UNITED STATES PATENT AND TRADEMARK OFFICE

| APPLICATION NO. | FILING DATE | FIRST NAMED INVENTOR | ATTORNEY DOCKET NO. | CONFIRMATION NO. |
|---|-------------|----------------------|---------------------|------------------|
| 10/575,860 | 01/25/2007 | Kyu Young Kim | K-0800 | 6863 |

Office Action Summary

DETAILED ACTION

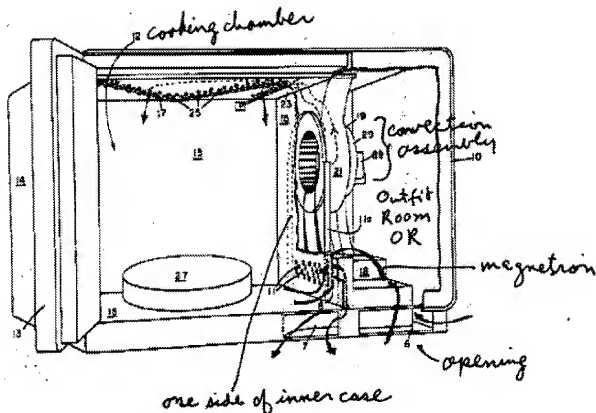
Larsen shows a microwave oven comprising: a body 10 forming an outer appearance; an inner case 15 in the body having a cooking chamber 12 formed therein; an outfit room (marked as OR) at one side of the inner case, having various electric parts, (including a magnetron 18, a high voltage transformer 92), mounted therein; and a convection assembly (19, 21, 29) mounted at a side of the inner case, for transmitting heat to the cooking chamber and a convection heater 17 for generating heat for convection heating (see the marked-up copy of Figure 1 below).

As set forth above, Larsen shows every feature as claimed except for the location of the convection heater 17. Tanaka shows a microwave oven having a convection assembly chamber 20 located adjacent to the inner casing with a cooking chamber 2. A convection assembly including a convection fan 17 surrounded by a ring shaped heater 15 as a convection heating element for convection heating of food items 31 in the microwave cooking chamber (see Figures 1-3 and 6-9 and col. 3, line 32 – col. 4, line 15). It would have been obvious to an ordinary skill in the art at the time of invention to modify Larsen to locate a convection heater surrounding the convection fan so that the heated air can be directed forced into the cooking chamber for more efficient and better cooking result, in view of the teaching of Tanaka. In regard to claim 26, the use of temperature sensors in a microwave convection combination is well known. For instance, Larsen teaches the use of a temperature sensing system 30 (see col. 4, lines 1-9) and Tanaka uses
